Response to the Reviewers' Comments

The authors would like to thank the reviewers for the precious comments and suggestions on the technical contents and presentation of our manuscript “Runtime Power Management of Battery Electric Vehicles for Extended Range with Consideration of Driving Time,” submitted to IEEE Transactions on Very Large Scale Integration (TVLSI.) This revised manuscript has been greatly improved thanks to the reviewers’ invaluable advices. We have revised the manuscript faithfully following the reviewers’s comments. We include the newly added or significantly modified parts in the revised version of the paper also in Response to Reviewers. We highlight the important technical content changes and set those parts in a red color in the revised paper.

Fig. 2: (a) Range-speed experimental data for Chevrolet Bolt [36] and (b) comparison with simulation results of the proposed EV power model.

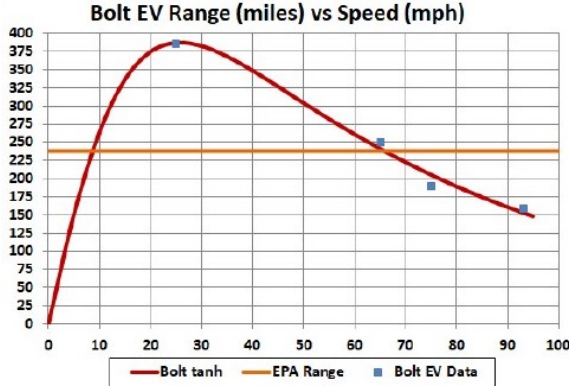
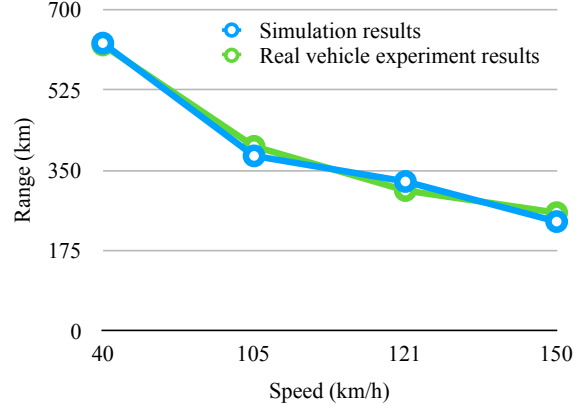
R1-C2 It is not clear how to validate the power model of EV. As the author mentions that accuracy of power model is quite important, it is good to see the power model in this paper can be validated by some real measurement results.

We further evaluate the model accuracy with the range-speed real vehicle experiments as shown in Fig. 2(a) to confirm the derived power models are close enough to the real vehicle measurement data [32], [33], [34], [35], [36]. We refine the coefficients until all the available data values match well.

As a result, the derived EV power model well matches with the range-speed experimental data as shown in Fig. 2(b) as well as the top speed and maximum acceleration setting the aerodynamic resistance, rolling resistance, curb weight, etc. with the known values. The errors in the range-speed simulation is merely 1.4%, the time for 0-to-100 km/h error is 7.8%, and the top speed error is 3.0%, respectively. We revised the manuscript adding the following paragraph with a new figure in Section III.A on page 3 and 4.

We further evaluate the model accuracy with the range-speed real vehicle experiments as shown in Fig. 2(a) to confirm the derived power models are close enough to the real vehicle measurement data [32], [33], [34], [35], [36]. We refine the coefficients until all the available data values match well.

As a result, the derived EV power model well matches with the range-speed experimental data as shown in Fig. 2(b) as well as the top speed and maximum acceleration setting the aerodynamic resistance, rolling resistance, curb weight, etc. with the known values. The errors in the range-speed simulation is merely 1.4%, the time for 0-to-100 km/h error is 7.8%, and the top speed error is 3.0%, respectively.

Fig. 12: Velocity profile comparison with EDP , E^2DP and E^3DP on Serrano Avenue in Anaheim Hills.

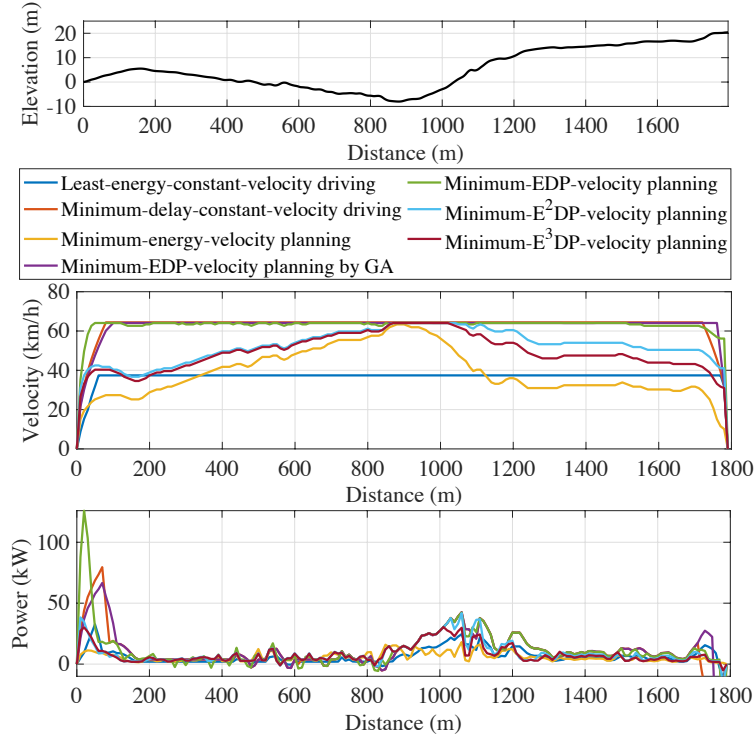
R1-C3 The optimality of the proposed scheduling algorithm is unclear. The author should add several paragraphs to discuss this topic. It is also to see the comparison baseline is well accepted to show the advantage of the proposed algorithm.

We also updated Fig. 12 and Fig. 13:

Fig. 11: Histograms of velocity and acceleration for the proposed energy-aware-velocity planning methods without an acceleration constraint (a) and (b) and with an acceleration constraint (c) and (d), respectively.

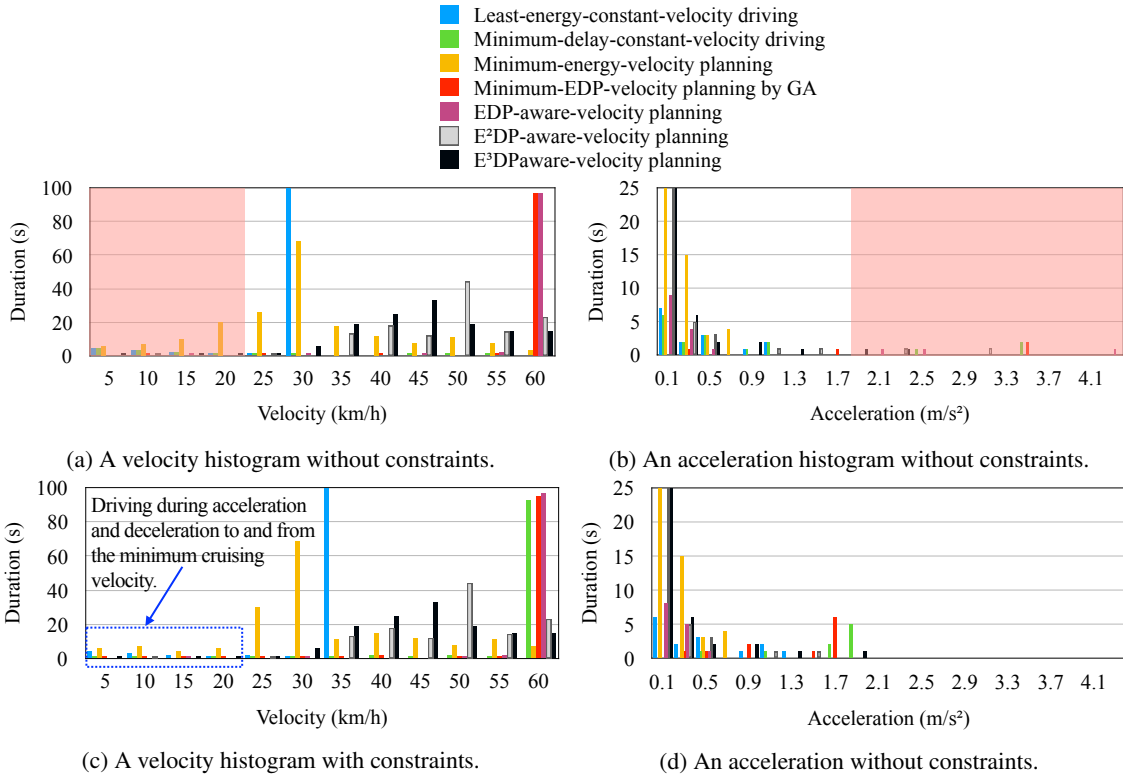
R2-C2 It would be good to have more discussion on the assumptions of the approach and the experiments, e.g., how much can the velocity be changed in practical scenarios without impeding traffic and causing unsafe situations (also depending on the road conditions and whether it is urban or rural environment I suppose). Currently, there only seems to be one constraint on not slower than 10 km/h.

We quantize the velocity and acceleration values and make a histogram to analyze population of velocity and acceleration for the proposed energy-aware-velocity planning methods. Fig. 11(a) and (b) show two histograms of the driving schemes in Fig. 12, which do not have velocity and acceleration constraints. We avoid a cruising

velocity lower than 25 km/h and an acceleration higher than 2.0 m/s^2 in this paper without loss of generality. The acceleration of 2.0 m/s^2 is the same as the maximum acceleration of compact cars designed to be used primarily used in urban areas (13 seconds of 0-to-100 km/h time).

Fig. 11(c) and (d) shows the velocity and acceleration histograms with the constraints. Once we run the DP for the first time without constraints, we analyze the histogram, adaptively determine the minimum cruising velocity and maximum acceleration constraints, and run DP again. We keep the same constraints for online recomputation whenever unexpected interrupts occurs.

Fig. 8: Altitude changes in the real road benchmarks.

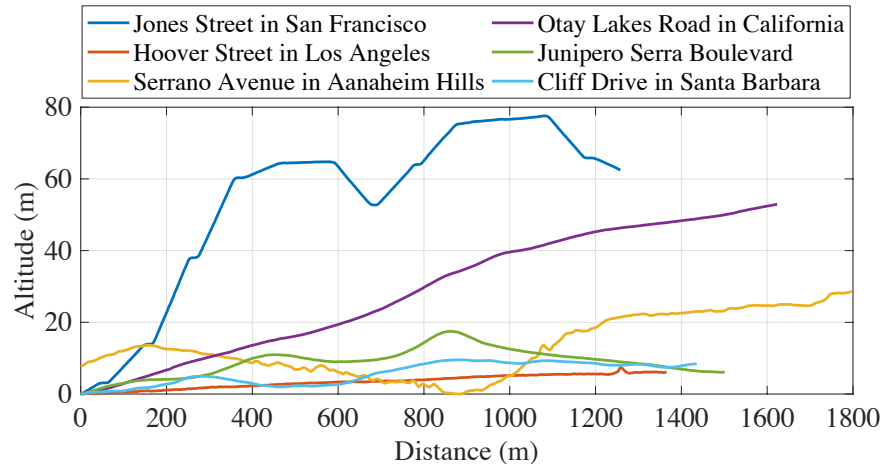
R2-C3 Related to the last point, it would be good to have more discussion on the road benchmarks, e.g., how they are generated and how representative they are. The optimization results significantly depend on road slope. It would be good to use a variety of real road segments for testing.

R2-A3 We appreciate the reviewer's comment. We replaced the previous synthetic road benchmarks with the real road benchmarks. We made six new real road benchmarks from various locations in California. The first three roads are in cities. Jones Street in San Francisco and Hoover Street in Los Angeles are two representative city landscapes such as hills and flat roads, respectively, and Cliff Drive in Santa Barbara is a mixture of those. The second two roads are in mountain areas: Serrano Avenue in Anaheim Hills and Otay Lakes Road in San Ysidro Mountain in California. The last road is Junipero Serra Boulevard connecting San Francisco and San Jose. The details of road data is summarized in Table II, and Fig. 8, which visualize the altitudes of the road benchmarks. We also revised all the associated contents with the new real road benchmarks.

We choose six roads from various locations in California and make real road benchmarks. The first three roads are in cities. Jones Street in San Francisco and Hoover Street in Los Angeles are two representative city landscapes such as hills and flat roads, respectively, and Cliff Drive in Santa Barbara is a mixture of those. The second two roads are in mountain areas: Serrano Avenue in Anaheim Hills and Otay Lakes Road in San Ysidro Mountain in California. The last road is Junipero Serra Boulevard connecting San Francisco and San Jose. The details of road data is summarized in Table II, and Fig. 8, which visualize the altitudes of the road benchmarks.
